Agenda
Village of Arlington Heights
Design Commission
Commissions Room 2nd Floor

Arlington Heights Village Hall
33 S. Arlington Heights Road
Arlington Heights, IL 60005
September 8, 2015
6:30 PM

**MINUTES OF
THE VILLAGE OF ARLINGTON HEIGHTS
DESIGN COMMISSION MEETING
HELD AT THE ARLINGTON HEIGHTS MUNICIPAL BUILDING
33 S. ARLINGTON HEIGHTS RD.
AUGUST 25, 2015**

H
RIGHT SIDE ELEVATION
SCALE: $1/4" = 1'-0"$

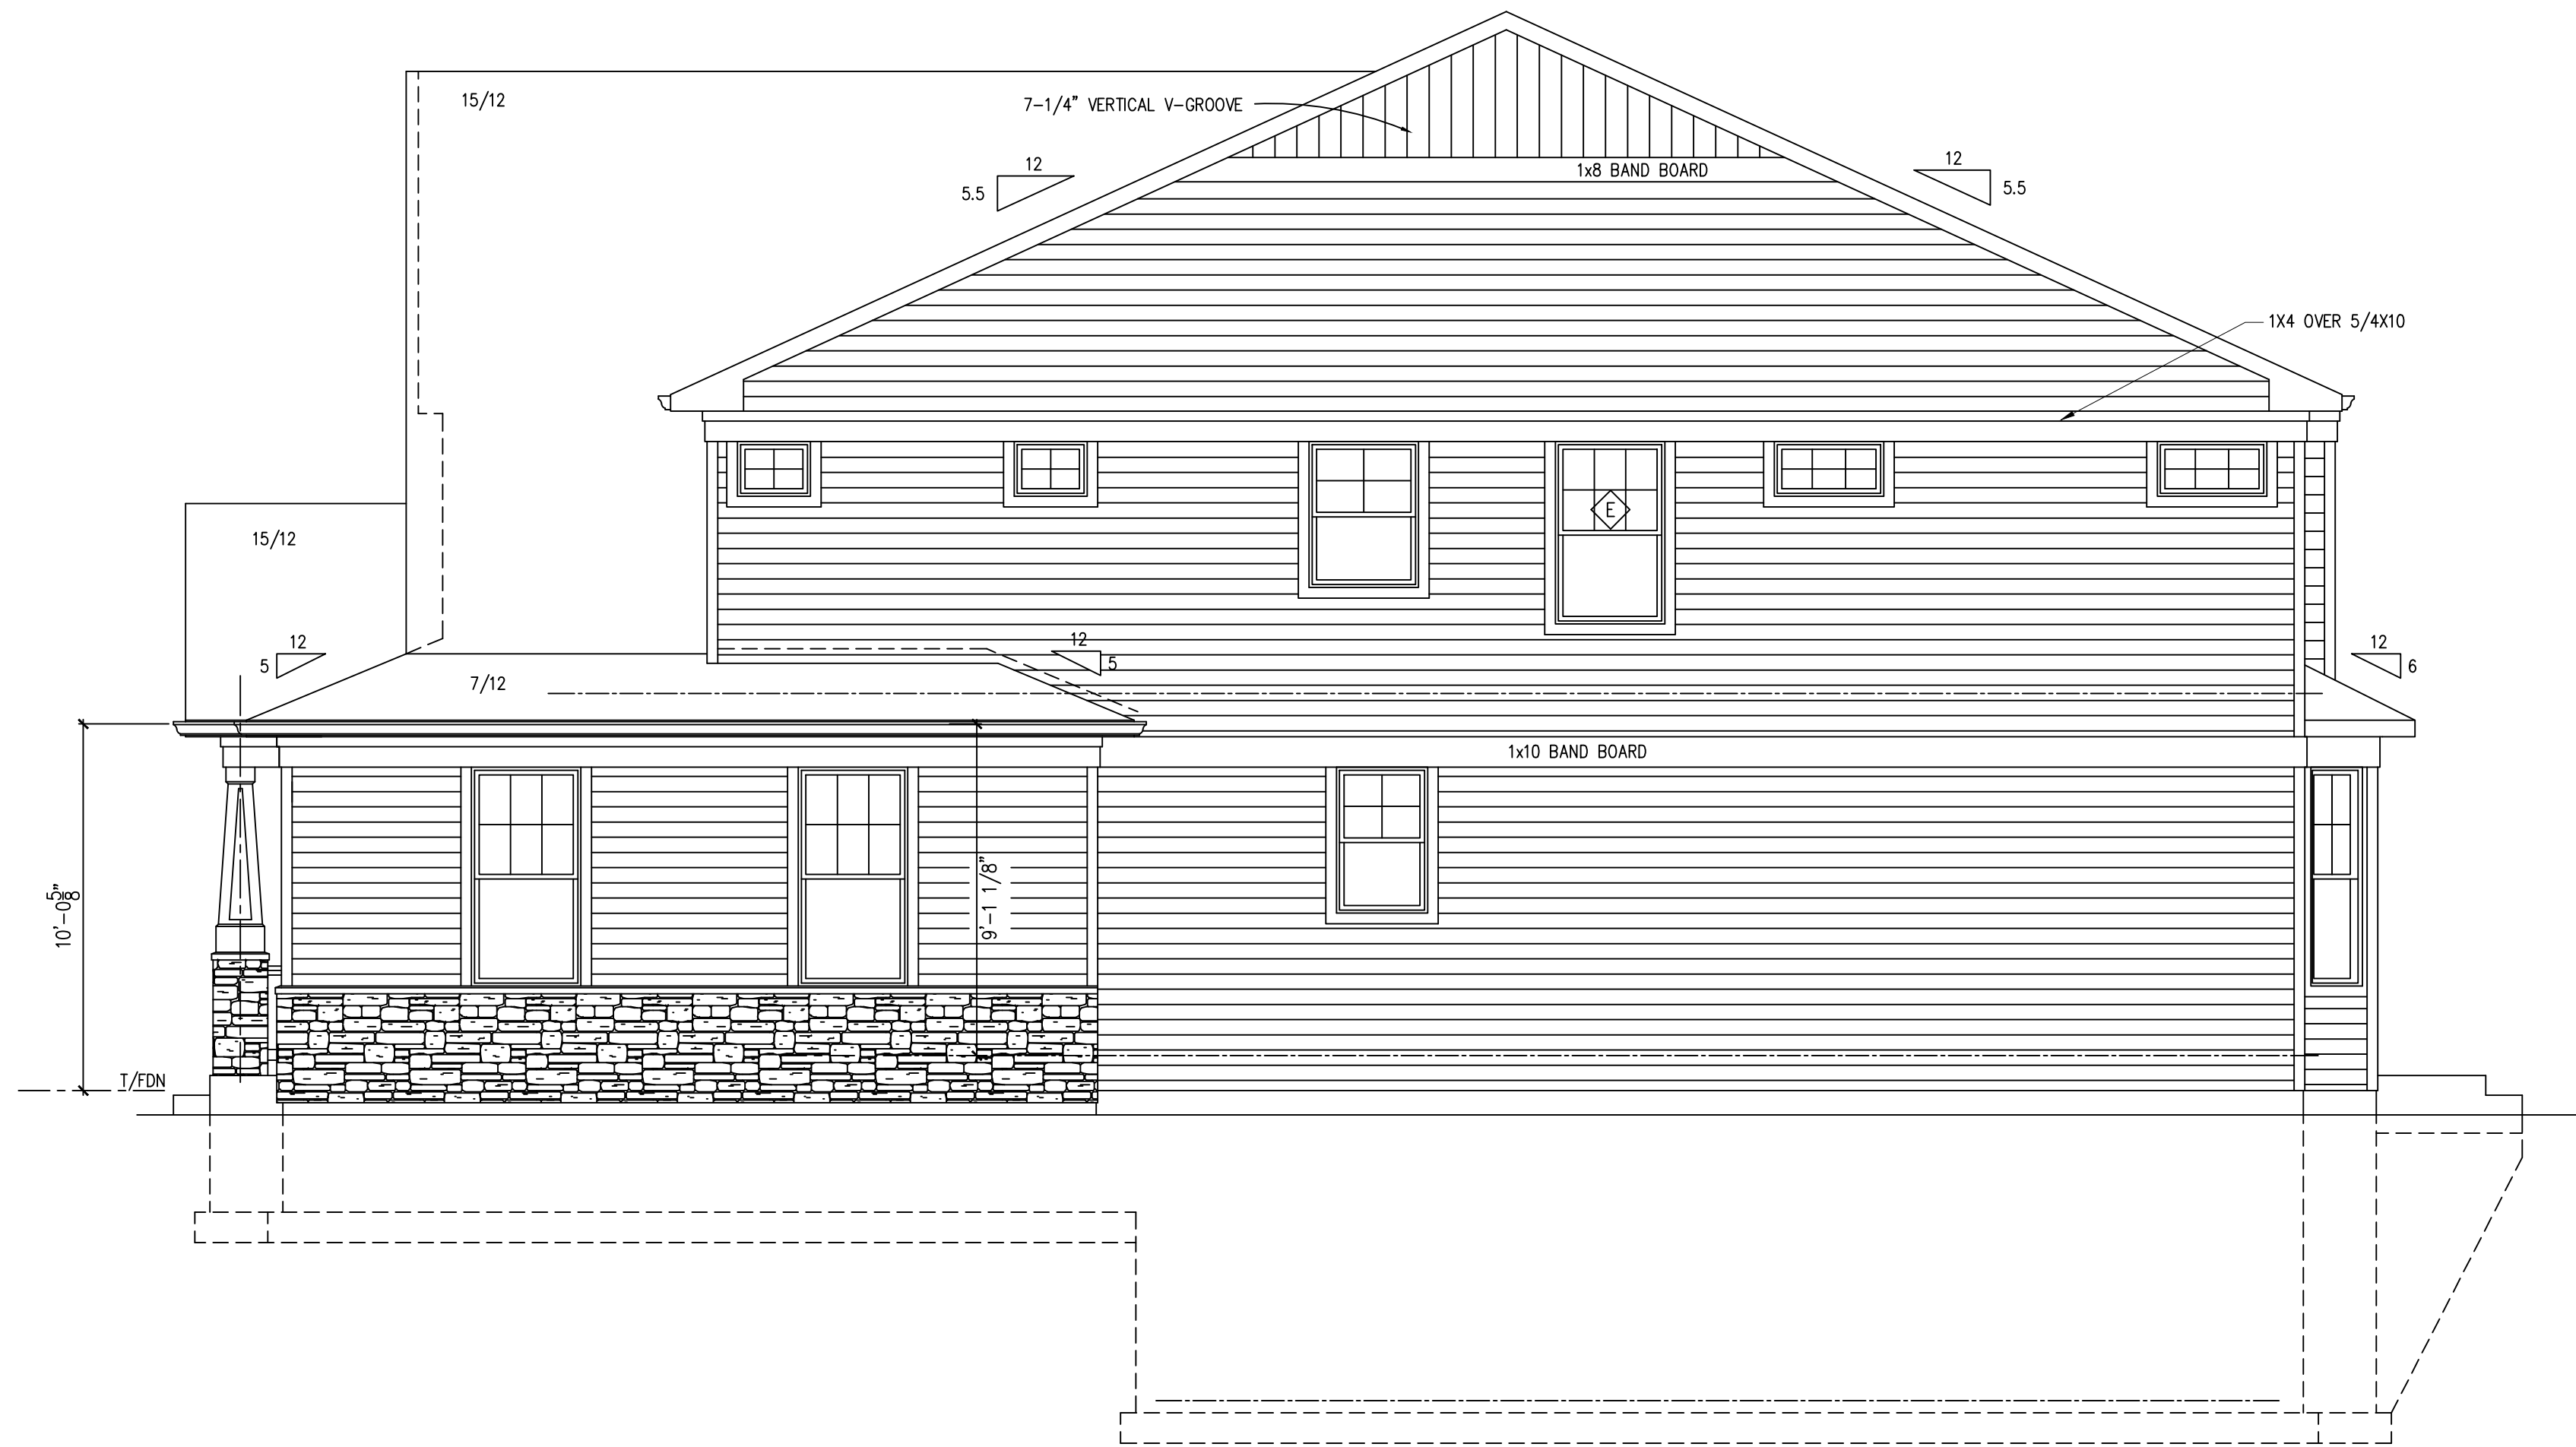
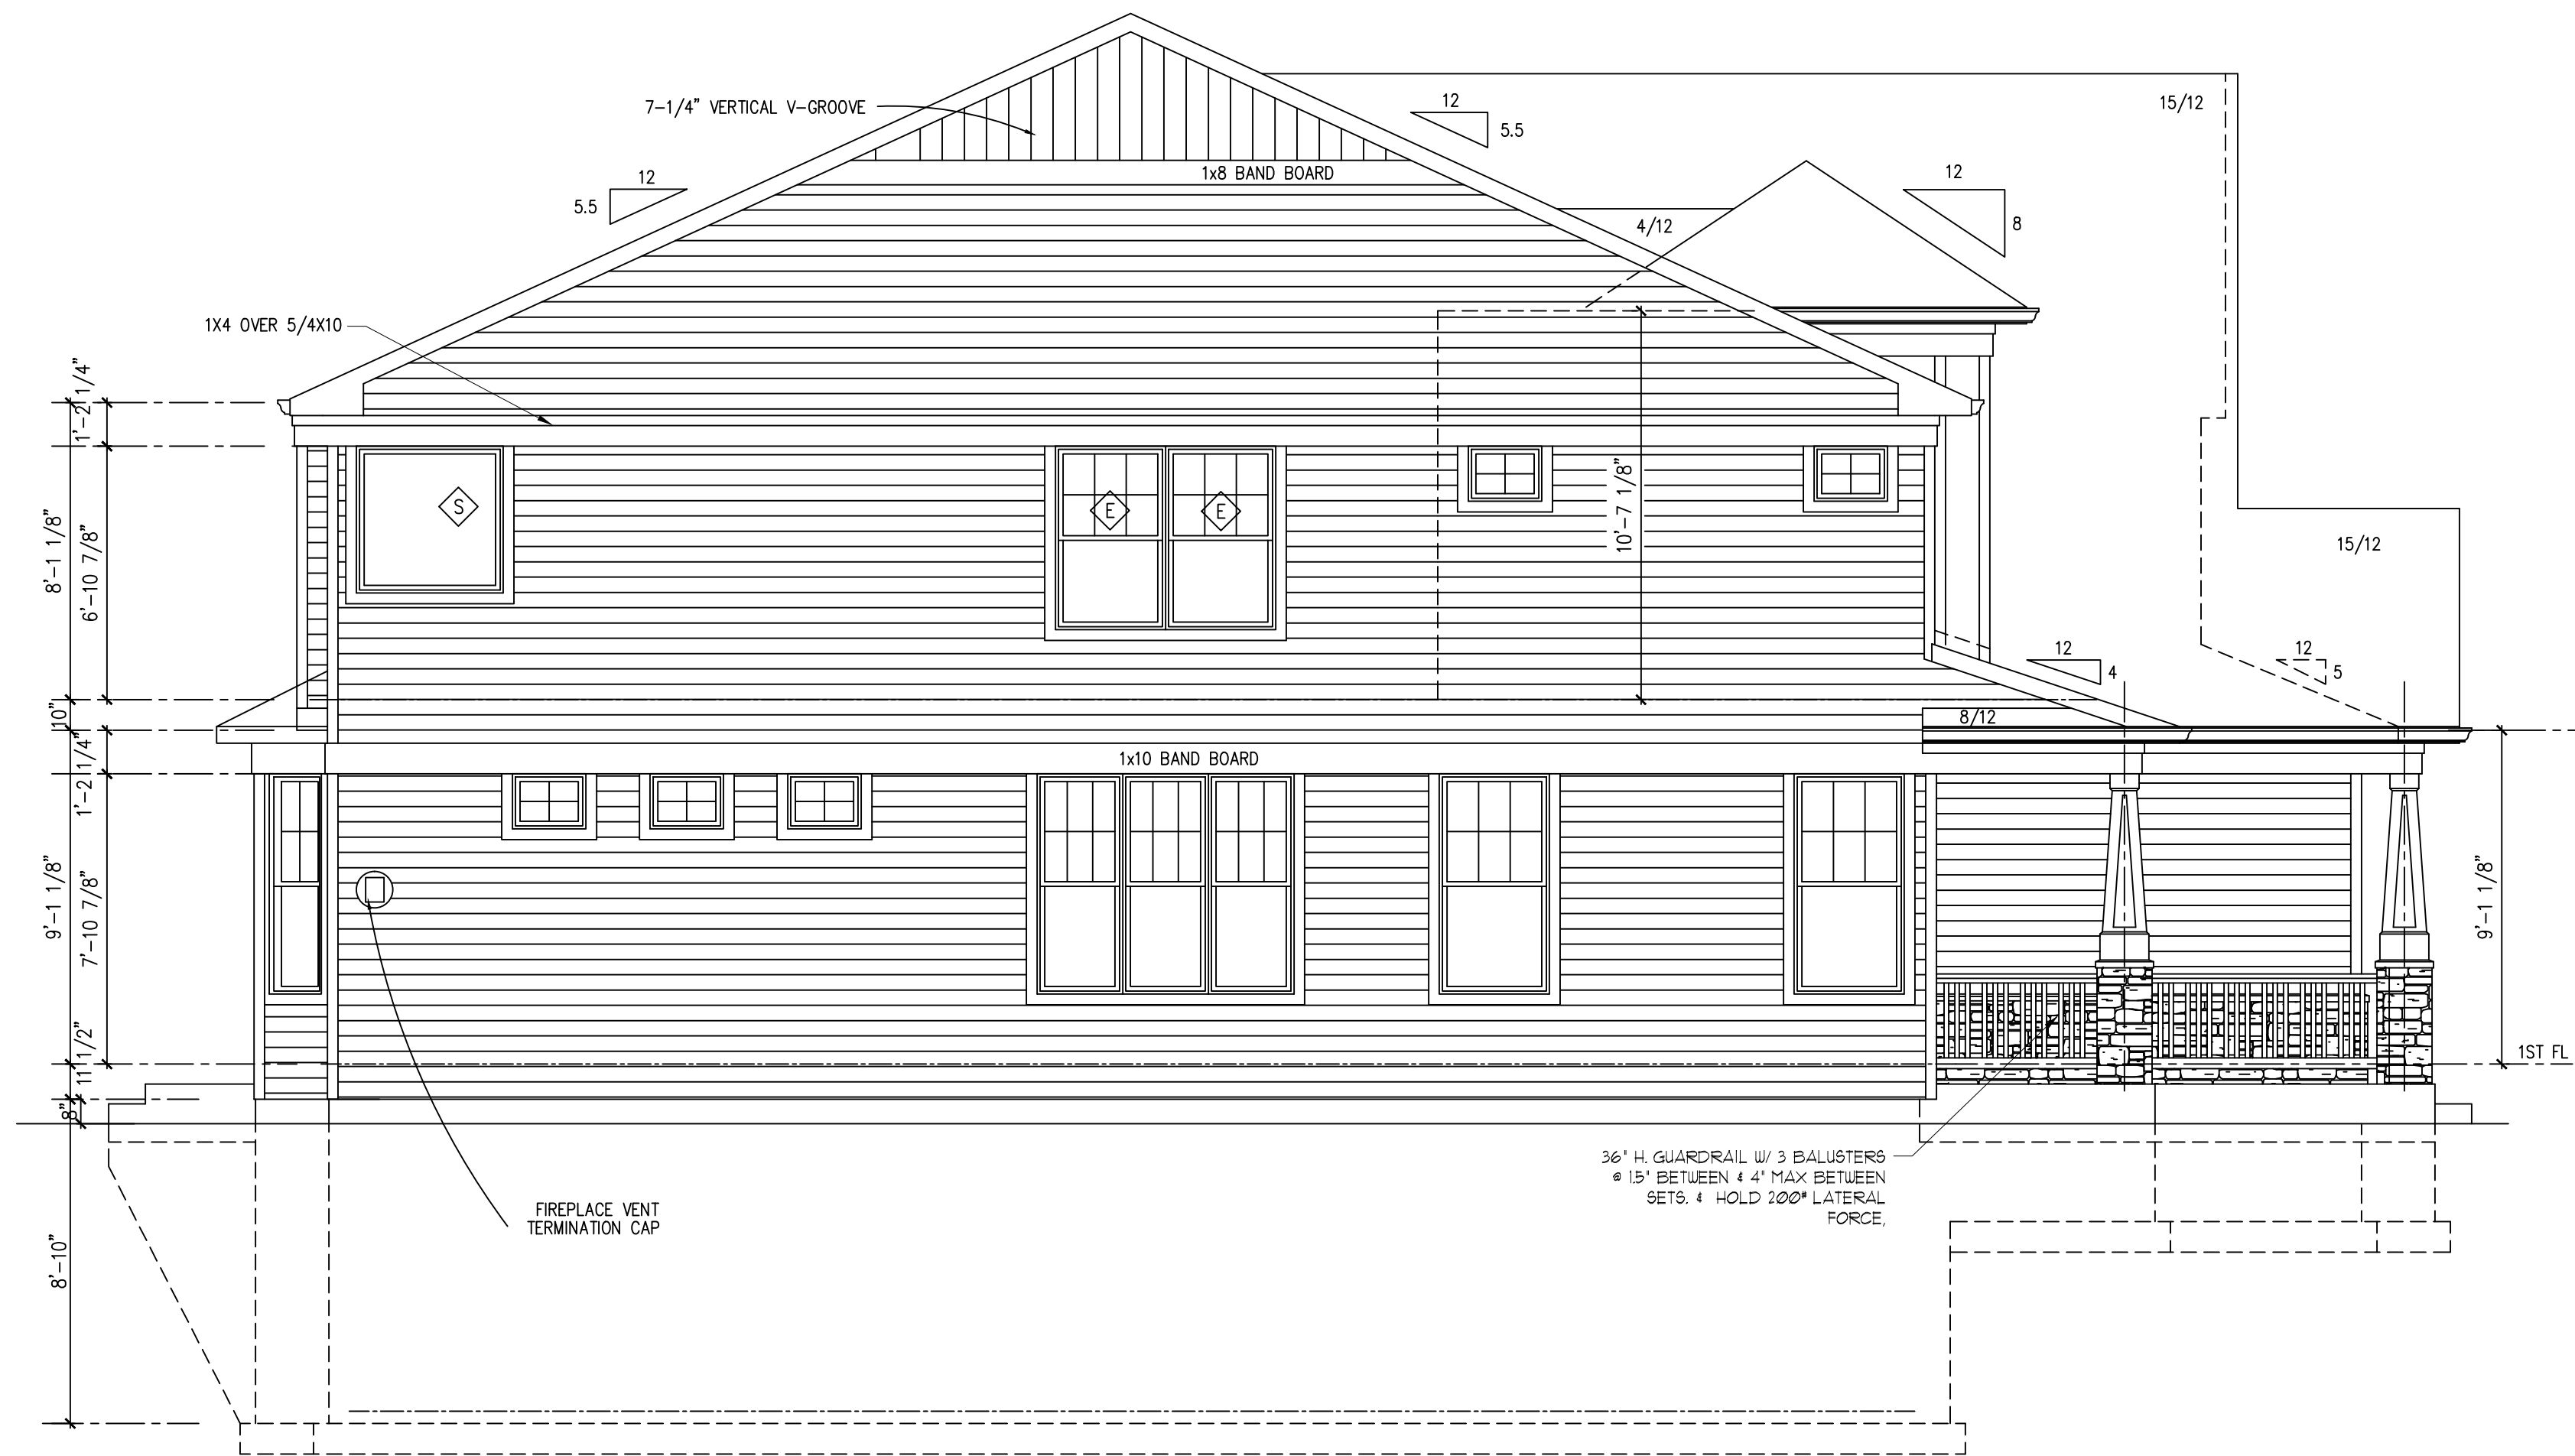
It is recommended that the Design Commission approve the proposed new single-family residence to be located at 1013 N. Beverly Lane. This recommendation is subject to compliance with the plans received 8/5/15, and the following conditions:
